TSG RAN Meeting #28**RP-050235****Quebec, Canada, 01 - 03 June 2005****Title CRs (Rel-6 cat. B) to TS25.423, TS 25.425 and TS 25.435****Source TSG RAN WG3****Agenda Item 8.11**

25.423 CR 1080 # rev **1** # Current version: **6.5.0**

Title:	# Congestion Control for HSDPA		
Source:	# RAN3		
Work item code:	# TEI6	Date:	# 11/05/2005
Category:	# B	Release:	# Rel-6
	Use <u>one</u> of the following categories: F (correction) A (corresponds to a correction in an earlier release) B (addition of feature), C (functional modification of feature) D (editorial modification) Detailed explanations of the above categories can be found in 3GPP TR 21.900 .		Use <u>one</u> of the following releases: Ph2 (GSM Phase 2) R96 (Release 1996) R97 (Release 1997) R98 (Release 1998) R99 (Release 1999) Rel-4 (Release 4) Rel-5 (Release 5) Rel-6 (Release 6) Rel-7 (Release 7)

Figure 12A: HS-DSCH DATA FRAME structure

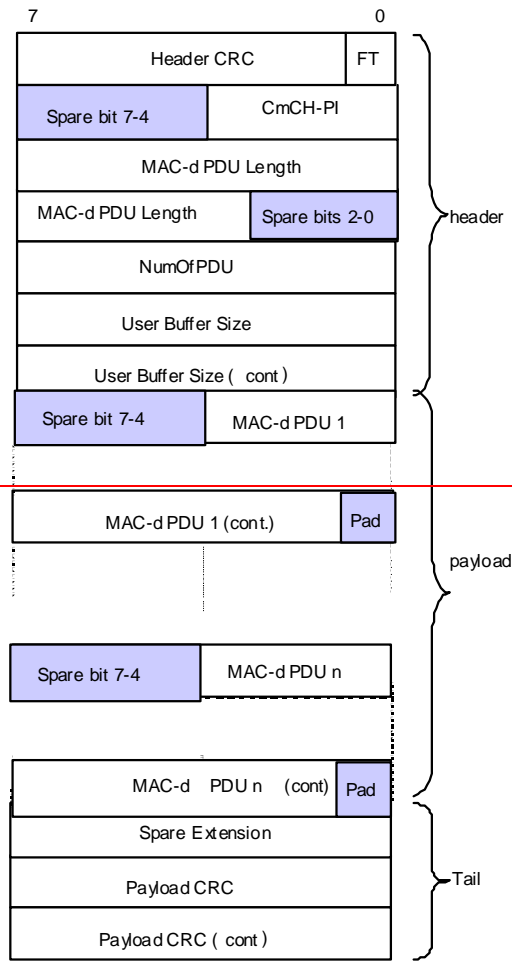
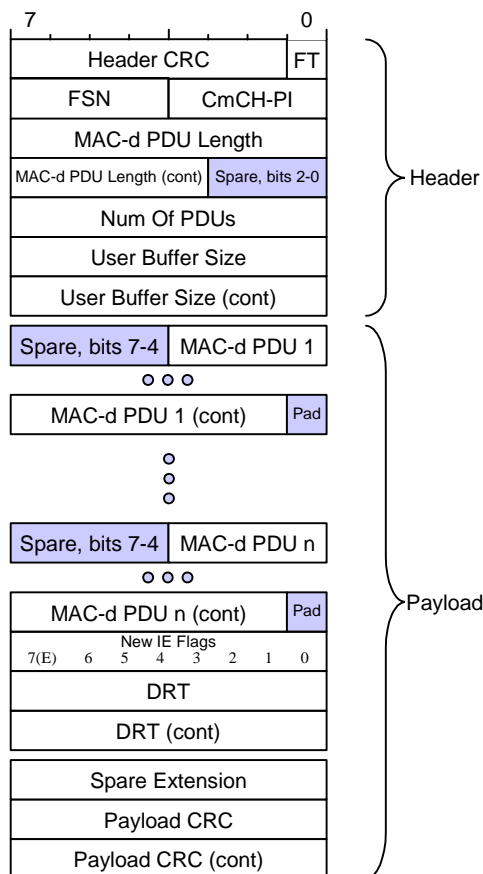
[For the purpose of TNL Congestion Control on HSDPA, the *Frame Sequence Number* and the *DRT* IEs may be included by the SRNC depending on higher layer configuration.](#)

[Bit 0 of New IE Flags in HS-DSCH DATA FRAME indicates if the 2 octets following the New IE Flags IE contains a valid DRT \(1\) or not \(0\).](#)

Figure 21A: HS-DSCH DATA FRAME structure

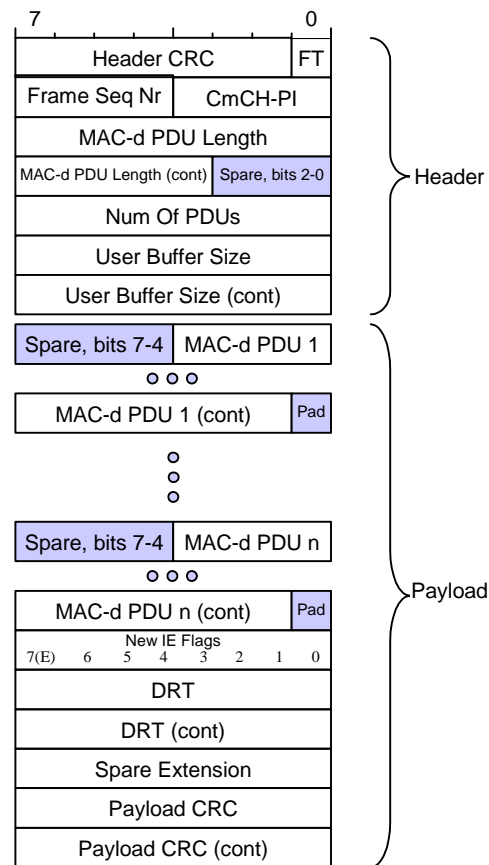
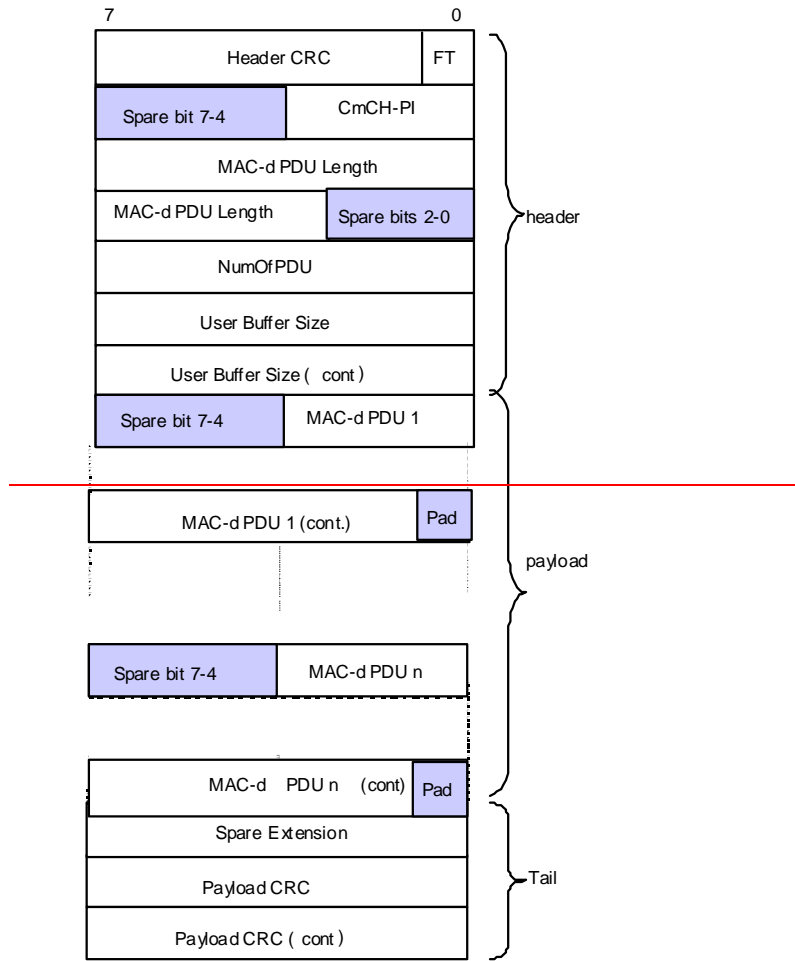
Bit 0 of New IE Flags in HS-DSCH DATA FRAME indicates if the 2 octets following the *New IE Flags* IE contains a valid DRT (1) or not (0).
